**Certificate of Appropriateness** BAR 19-04-02 134 10<sup>th</sup> St NW Tax Parcel 310156000 Shannon Worrell, Owner/Applicant Replace Loading Dock Door

# CITY OF CHARLOTTESVILLE BOARD OF ARCHITECTURAL REVIEW STAFF REPORT April 16, 2019

**Certificate of Appropriateness** BAR 19-04-02 134 10<sup>th</sup> St NW Tax Parcel 310156000 Shannon Worrell, Owner/Applicant **Replace Loading Dock Door**

134 Tenth St NW north elevation

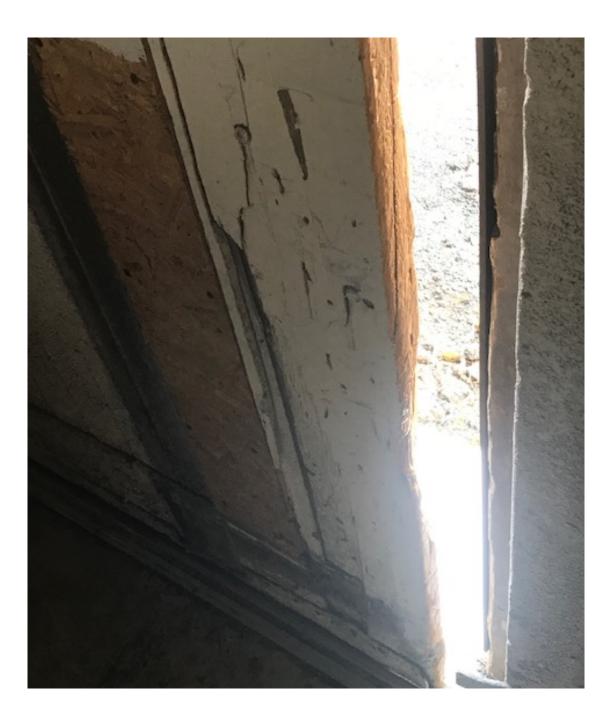
Door has been patched with sheets of galvanized metal and coated with Sprayed insulation like material to try to fill cracks and prevent Deteririation. Door does not close flush and is not possible to fully open and close without 2 or more people, causing a fire hazard and terrible Energy inefficiency.

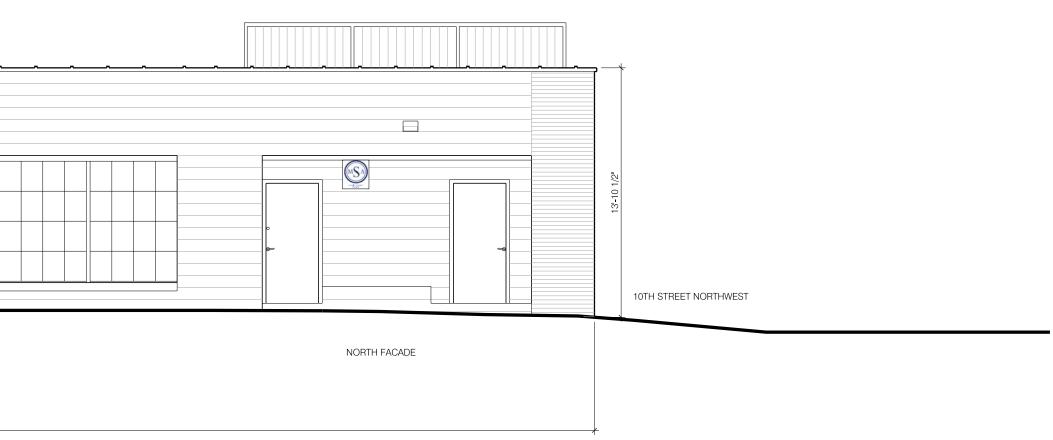
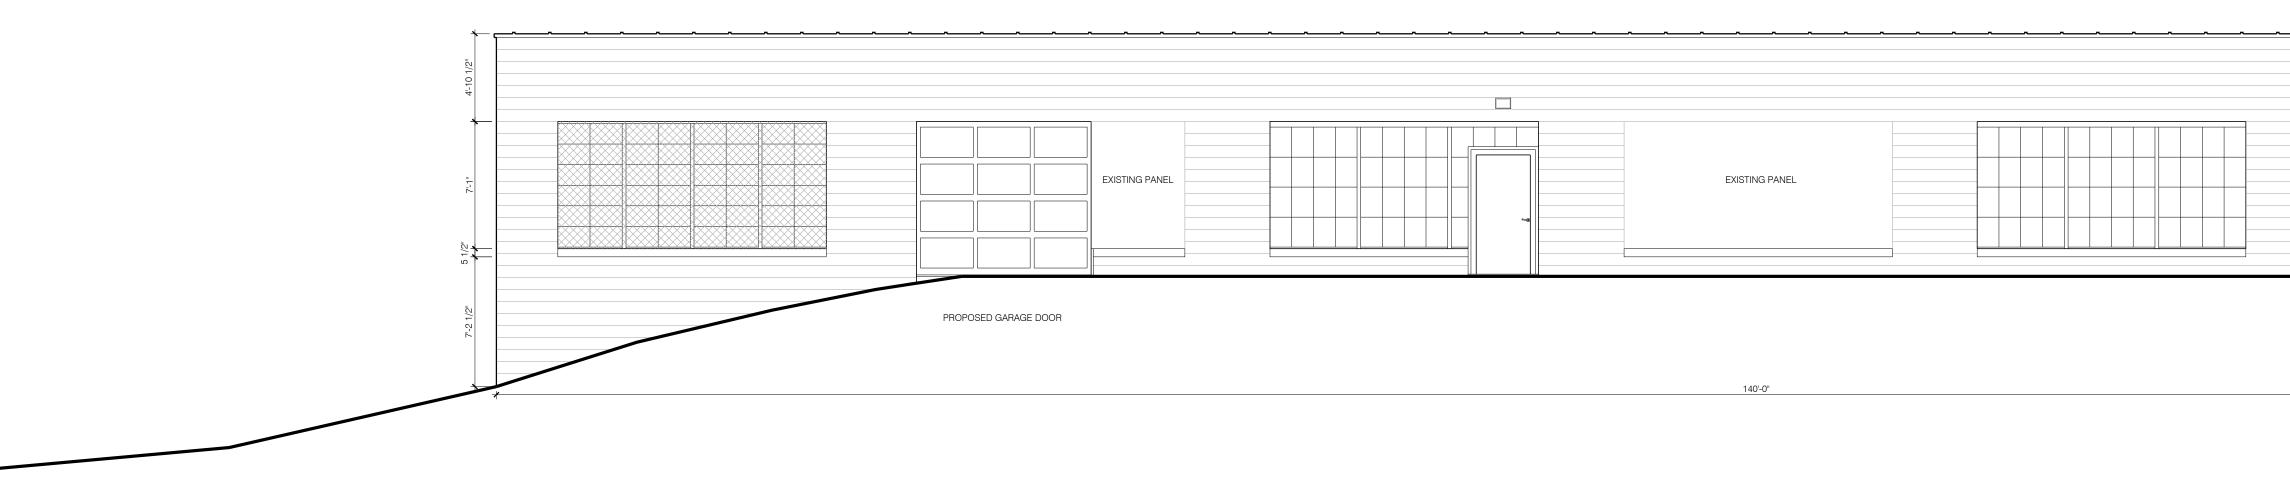
Staff finds the loading door replacement is compatible with the ADC Guidelines. Recommend the door be stored on site for possible future use.

Approved on the consent agenda. Having considered the standards set forth within the City Code, including City Design Guidelines for Rehabilitation, I move to find that the proposed loading dock door satisfies the BAR's criteria and is compatible with this Individually Protected Property and that the BAR approves the application as submitted. Approved (7-0).
